BID ADDENDUM NO. 4

Date of Addendum: April 17, 2026
Issued for Bid Date: March 27, 2026
Client Name: Public Schools of the Tarrytowns
Project Name: 2024 Capital Bond Project – Phase 2; Washington Irving Intermediate School
SED Project No.: 66-04-01-03-0-002-017
TUFSD Bid Number: 25/26-TUFSD-003
MEMASI Project No.: 101-2403
Contracts: Contract 1: General Construction (GC)
Contract 2: Mechanical Construction (MC)
Contract 3: Electrical Construction (EC)
Contract 4: Plumbing Construction (PC)

A502

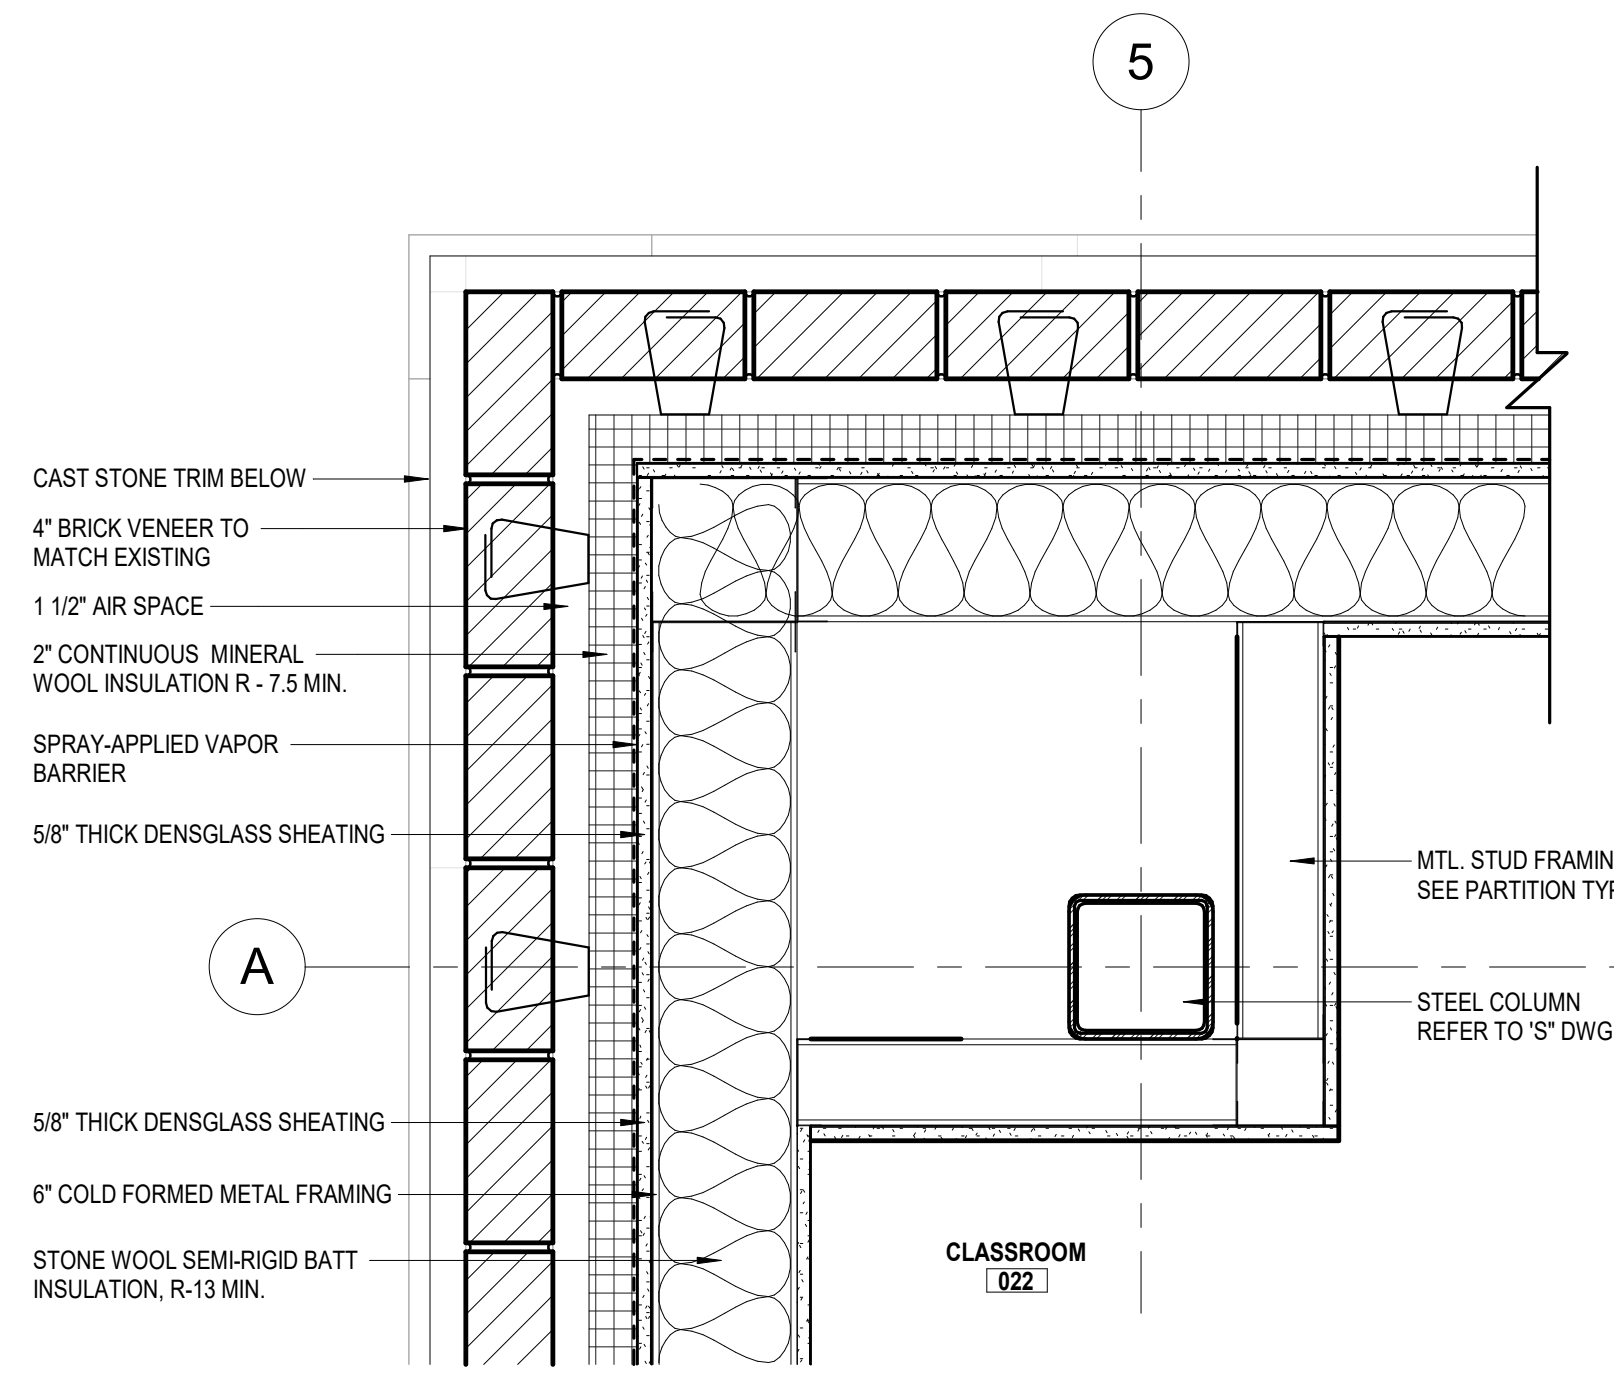
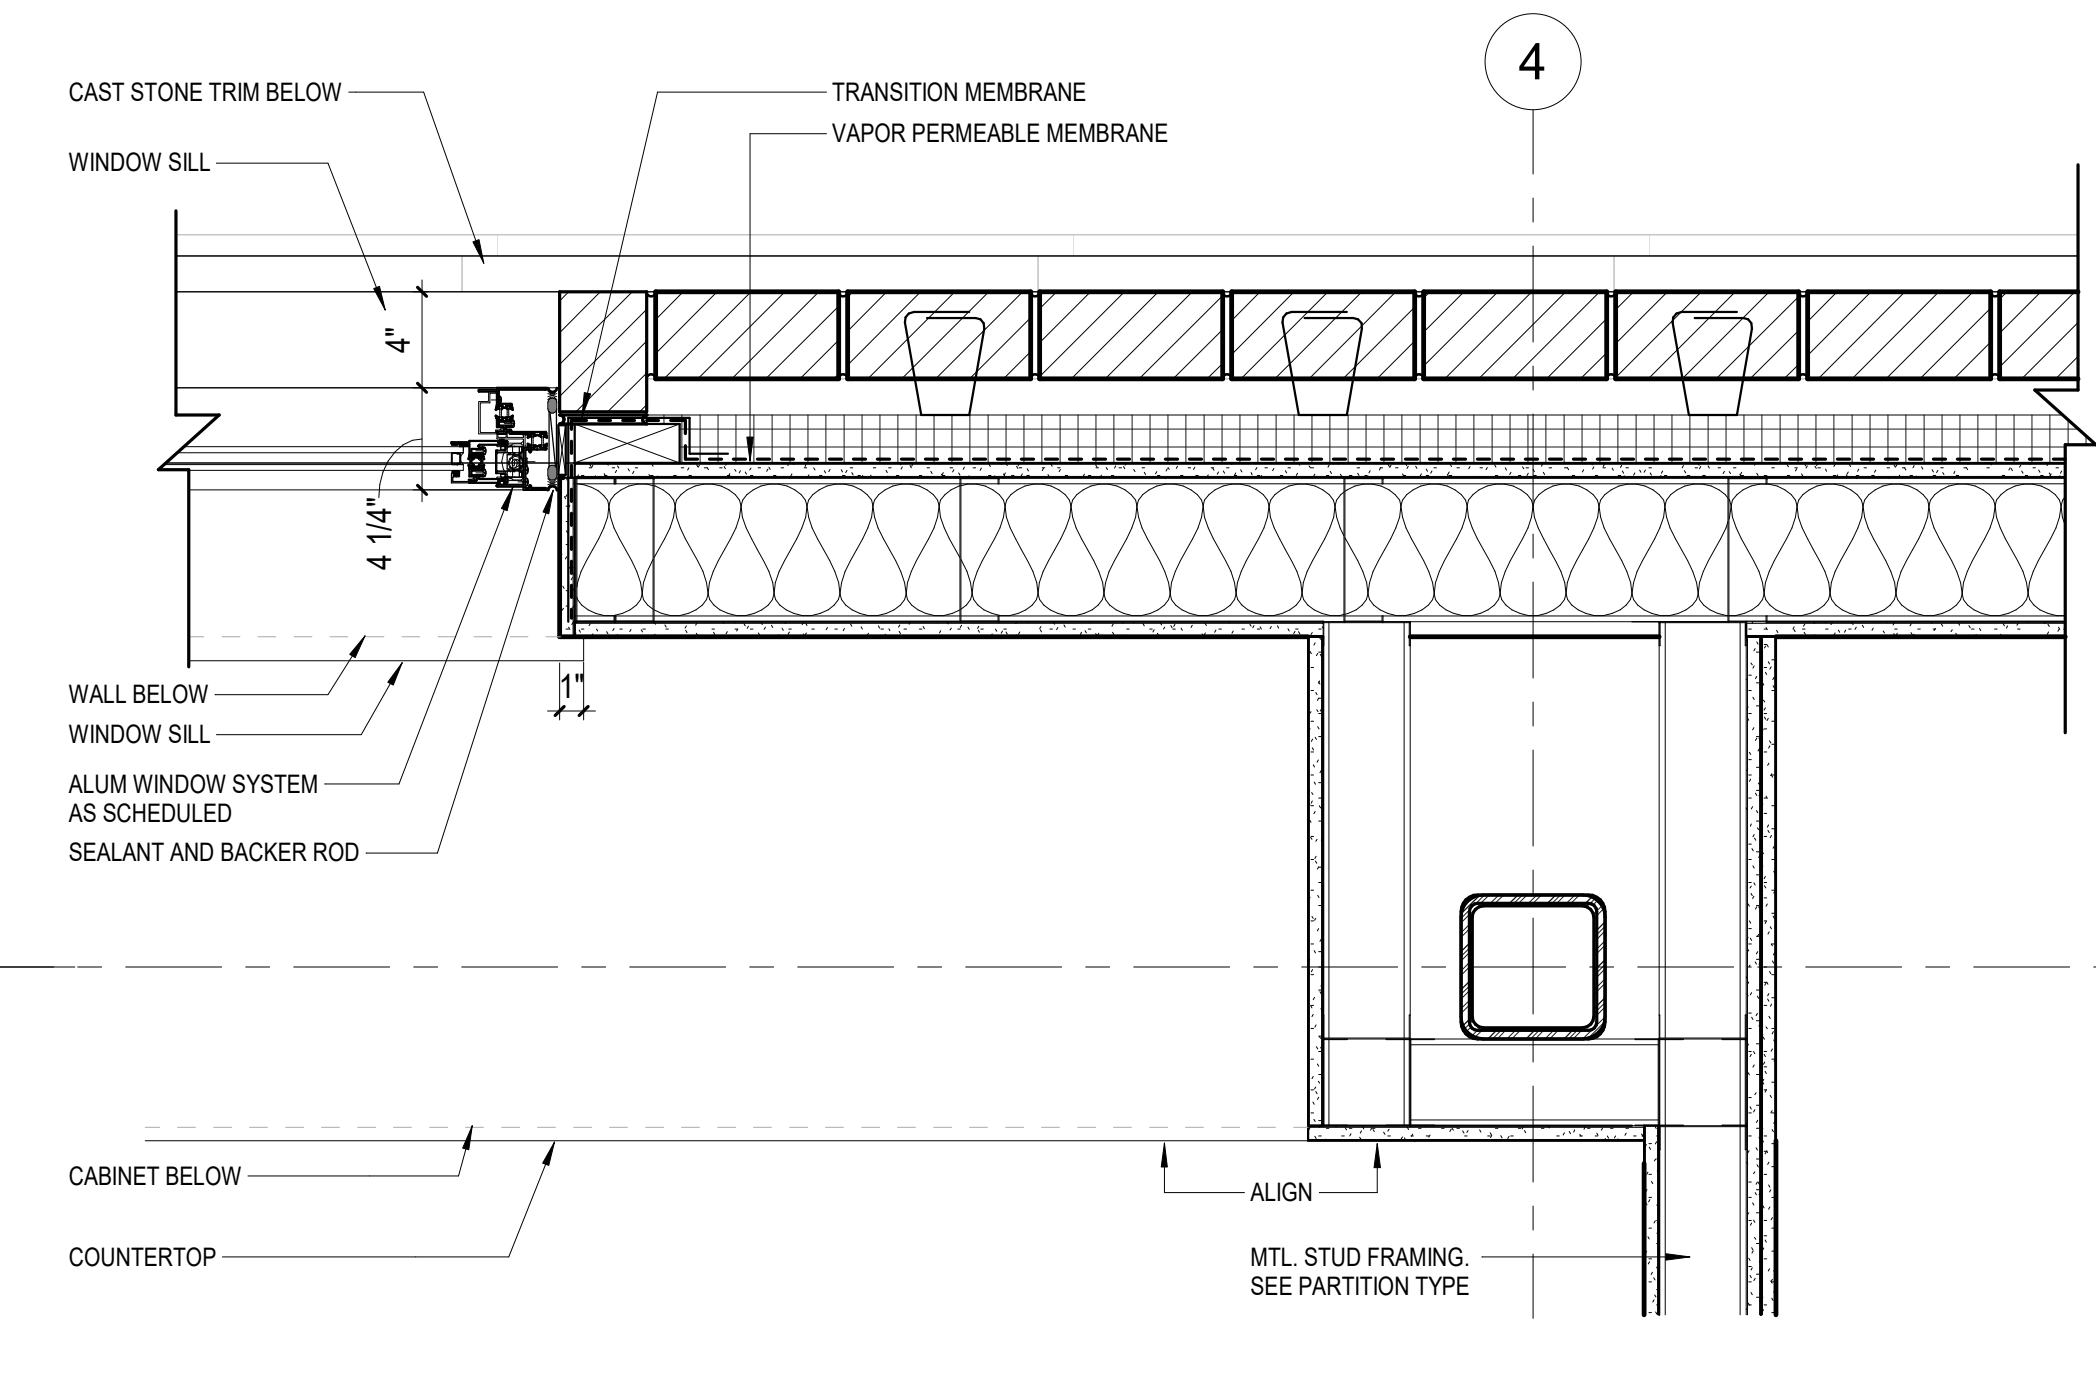
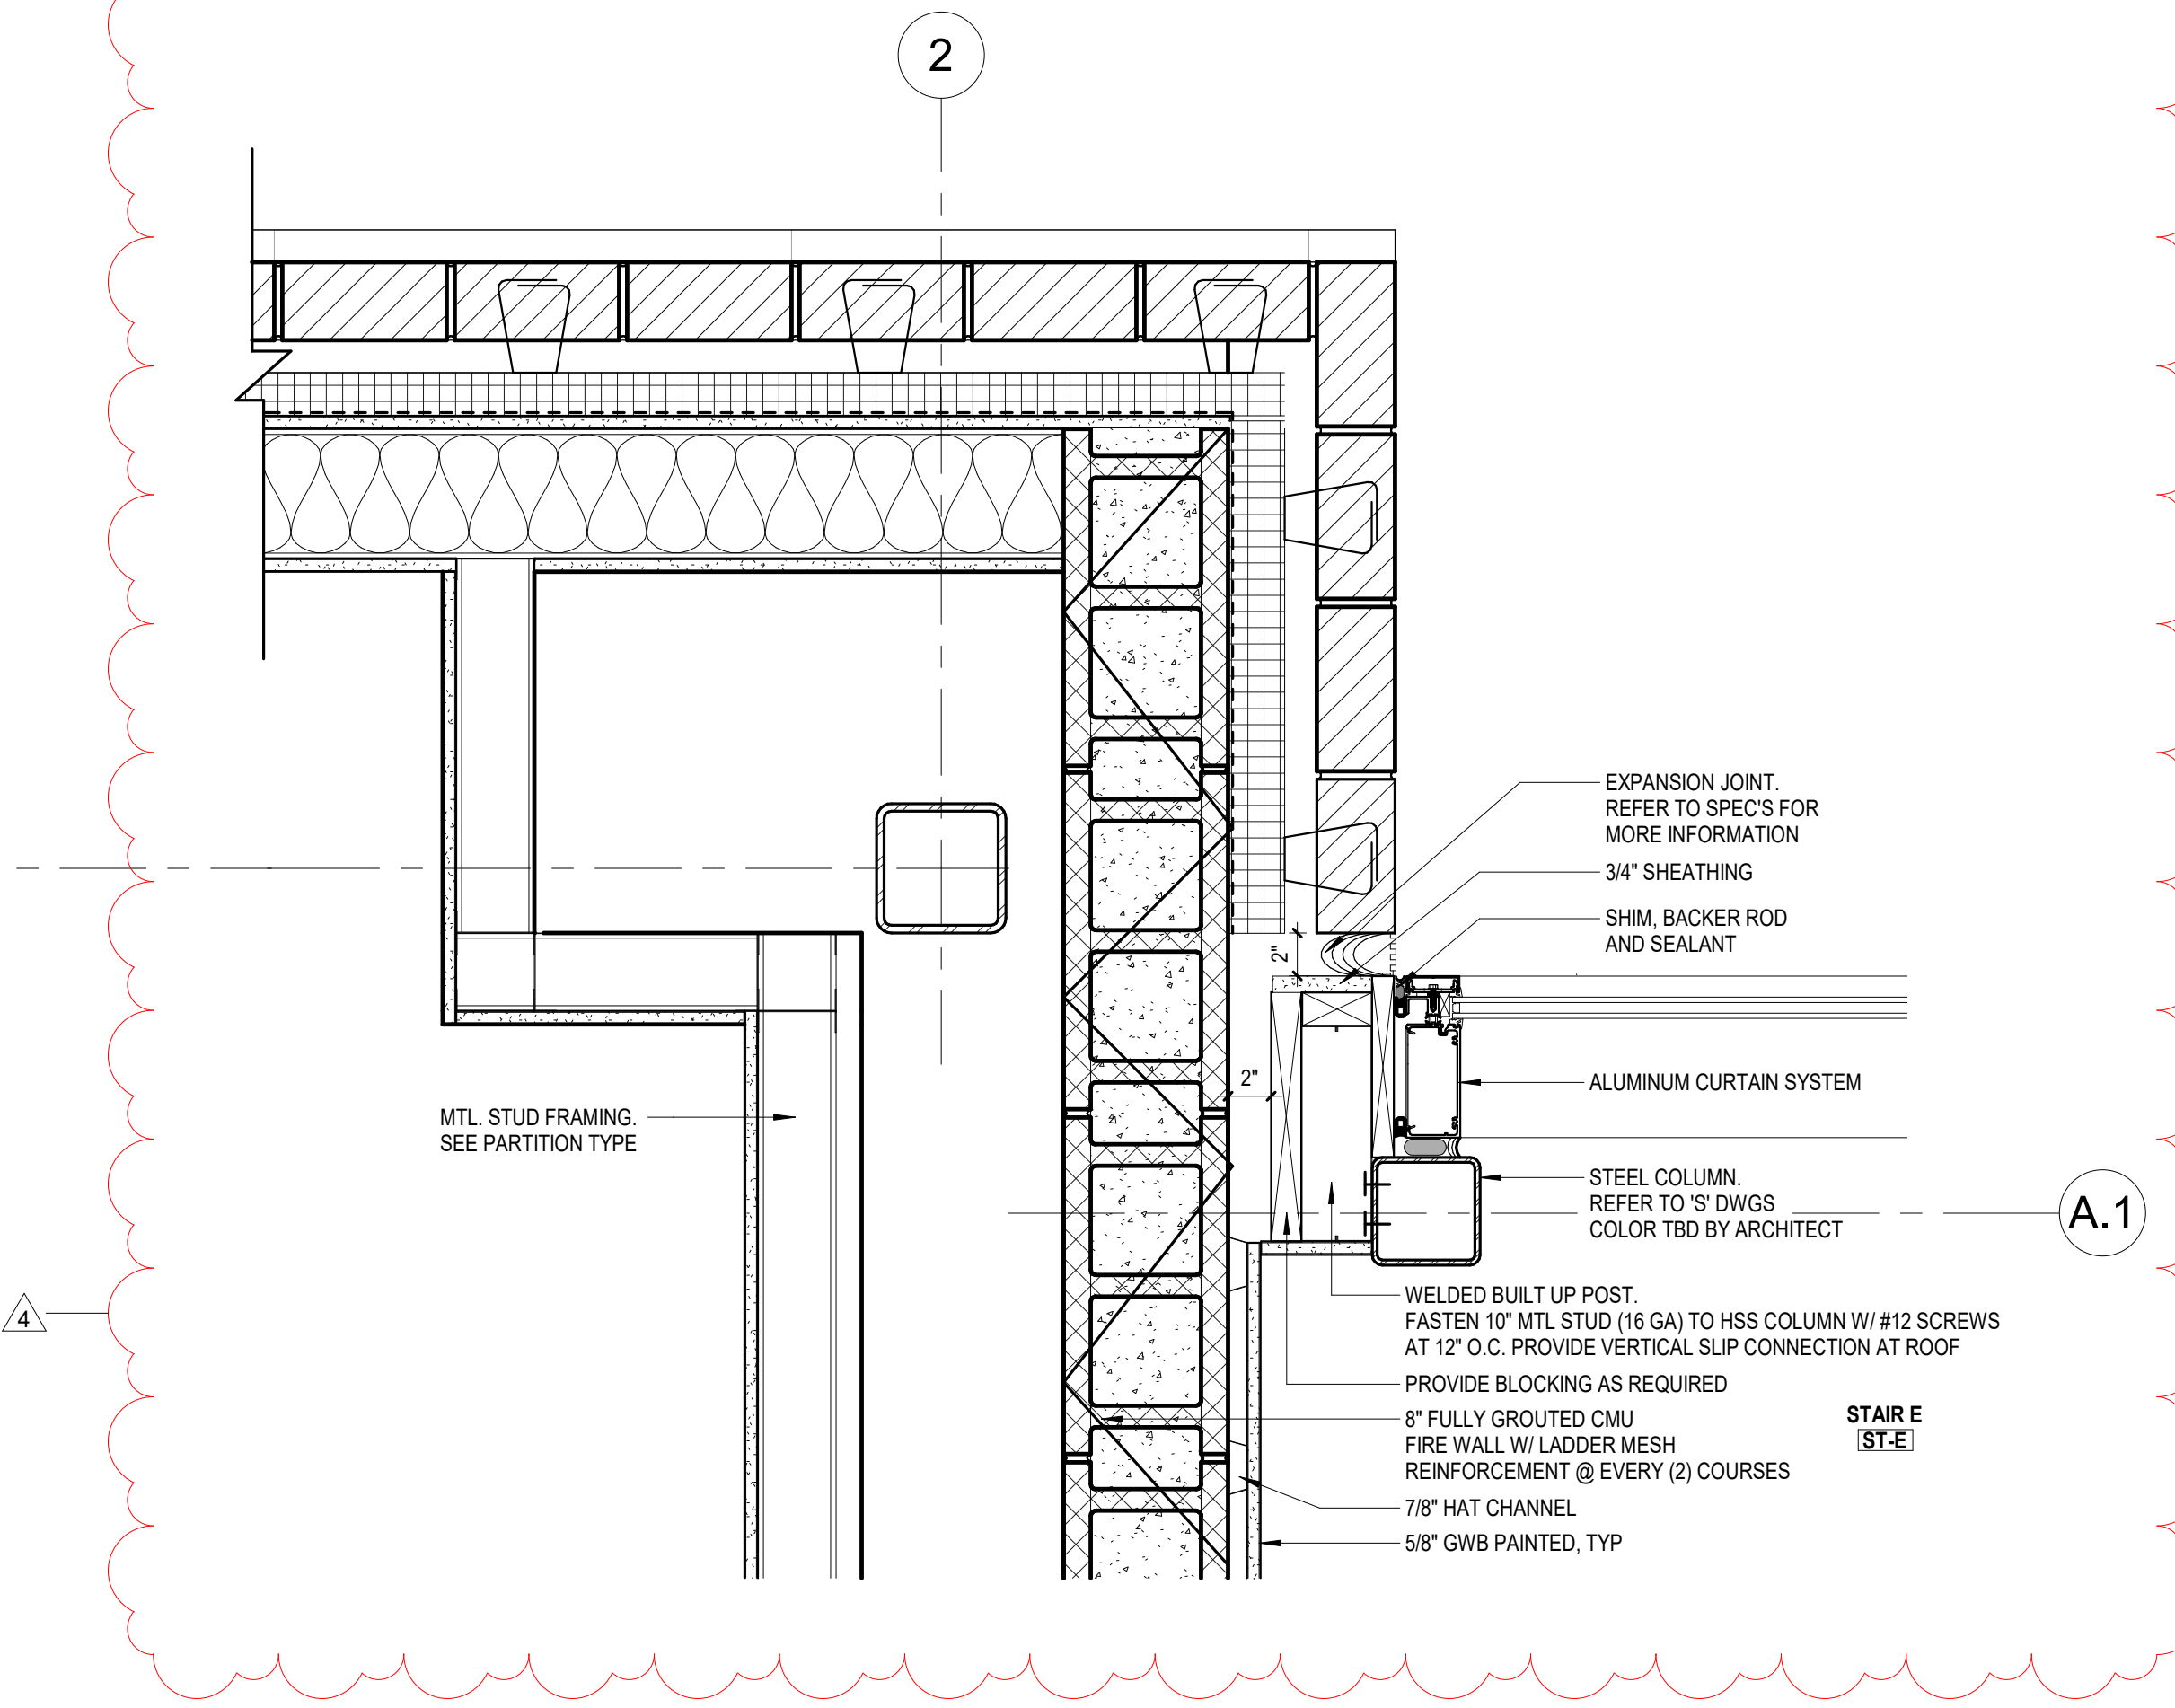
- h. SHEET A502 – PLAN DETAILS; DELETE existing Details 10/A502 and 20/A502 on sheet A502, dated 03/27/2026; ADD Details 10/A502 and 20/A502 on sheet A502, revised 04/17/2026, attached.
